Product Change Notification

TBU® HIGH-SPEED PROTECTORS

Change of Reel Hub Dimension for Bourns® TBU® High-Speed Protectors

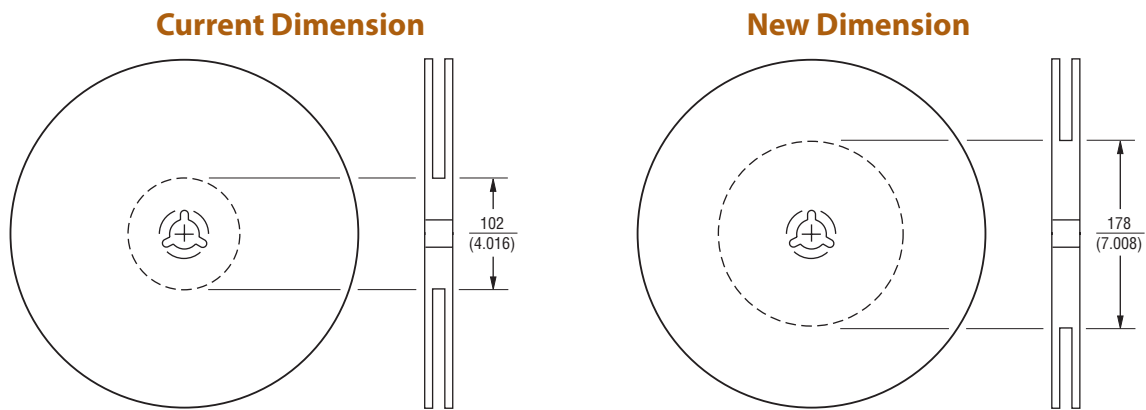
In the spirit of continuous improvement, the reels used to pack the below mentioned Bourns® TBU® High-Speed Protectors will have the reel hub dimensions increased from 4" (102 mm) to 7" (178 mm). This change will minimize the empty distance from the edge of the taped products to the edge of the reel.

The change in the reel's hub will have no effect on form, fit, function, quality or reliability of the Bourns® products themselves.
